# SITE DEVELOPMENT PLAN OF PROLOGIS PARK

REDLINE DESIGN PROFESSIONAL  
 (2/20/20 REVISIONS)  
 NJB ENGINEERING INC.  
 810 GLENAGLES COURT - SUITE 311  
 TOWSON, MARYLAND 21286  
 (410) 832-7691

**PROLOGIS PARK I-95**  
**PARCEL A-14**  
**SITE DEVELOPMENT PLAN**  
 ZONED M-1  
 TAX MAP 37 GRID 18  
 ELECTION DISTRICT No. 1 HOWARD COUNTY, MARYLAND

REMOVE MECHANICAL BUILDING, CHILLER YARD & TANK TRUCK LOADING STATION FROM LOT 1

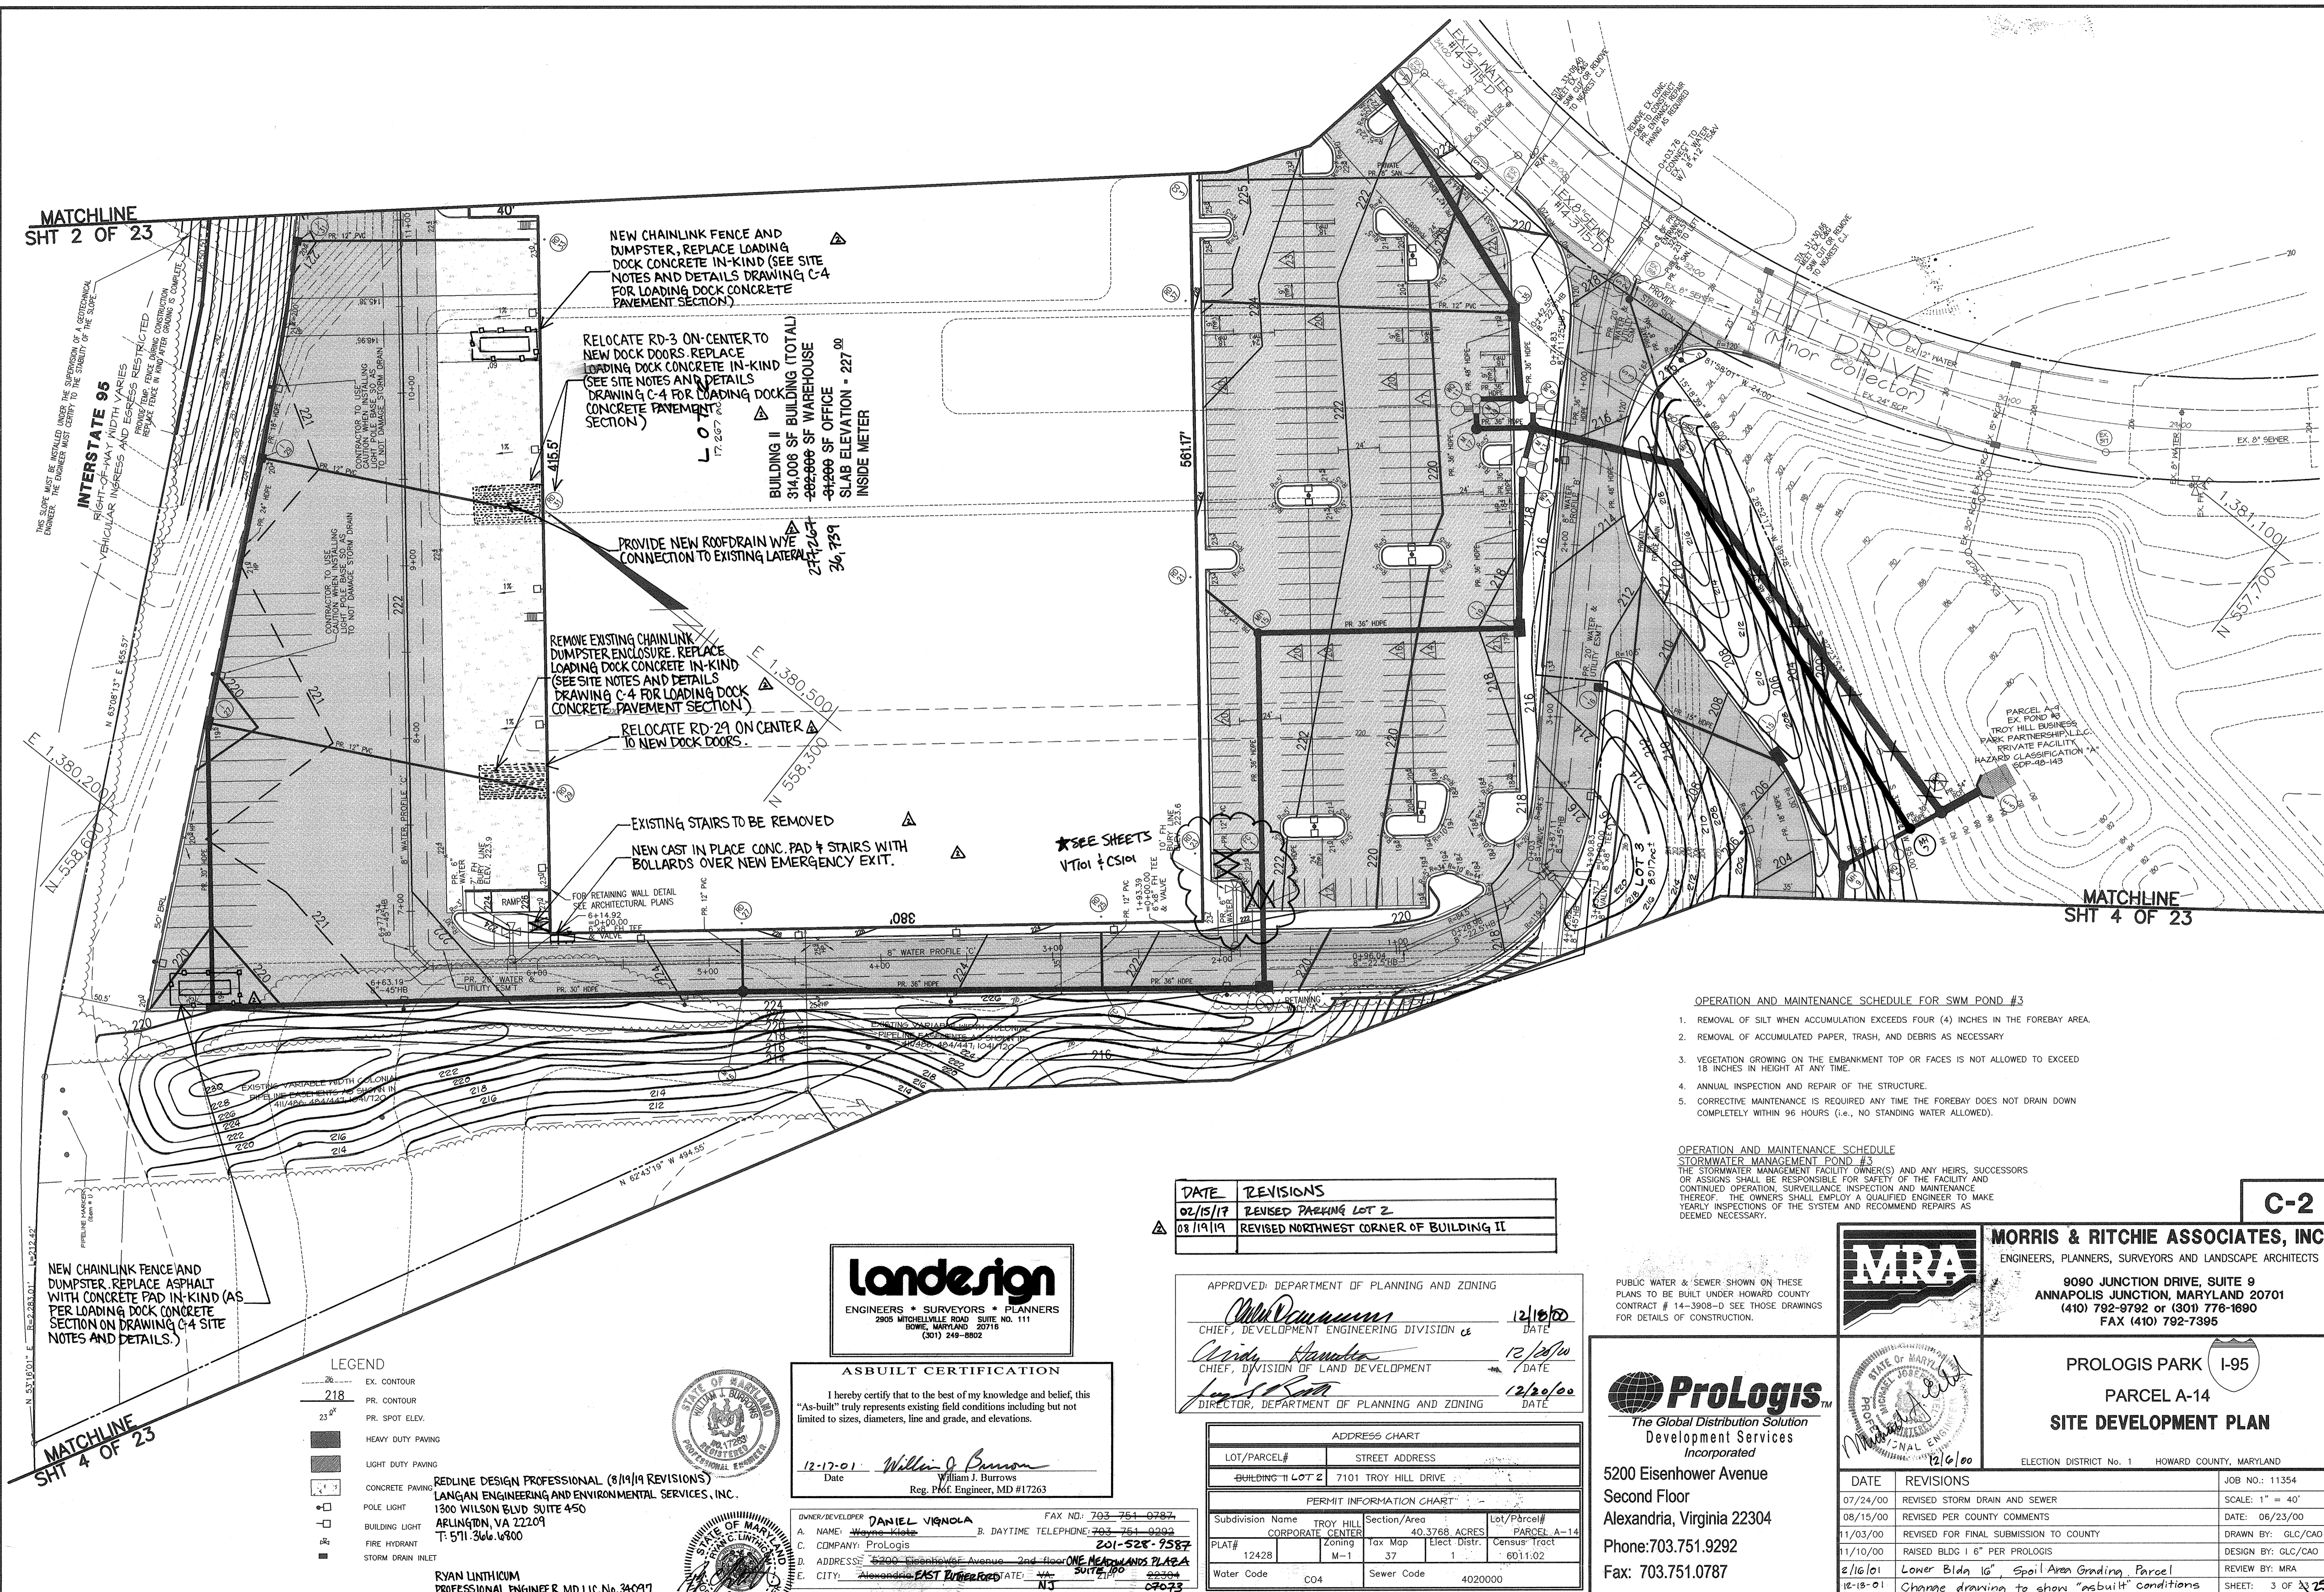
NEW CHAINLINK FENCE AND DUMPSTER, REPLACE LOADING DOCK CONCRETE IN-KIND (SEE SITE NOTES AND DETAILS DRAWING C-4 FOR LOADING DOCK CONCRETE PAVEMENT SECTION)

RELOCATE RD-3 ON-CENTER TO NEW DOCK DOORS. REPLACE LOADING DOCK CONCRETE IN-KIND (SEE SITE NOTES AND DETAILS DRAWING C-4 FOR LOADING DOCK CONCRETE PAVEMENT SECTION)

PROVIDE NEW ROOF DRAIN WYE CONNECTION TO EXISTING LATERAL

REMOVE EXISTING CHAINLINK DUMPSTER ENCLOSURE. REPLACE LOADING DOCK CONCRETE IN-KIND (SEE SITE NOTES AND DETAILS DRAWING C-4 FOR LOADING DOCK CONCRETE PAVEMENT SECTION)

NEW CHAINLINK FENCE AND DUMPSTER. REPLACE ASPHALT WITH CONCRETE PAD IN-KIND (AS PER LOADING DOCK CONCRETE SECTION ON DRAWING C-4 SITE NOTES AND DETAILS.)
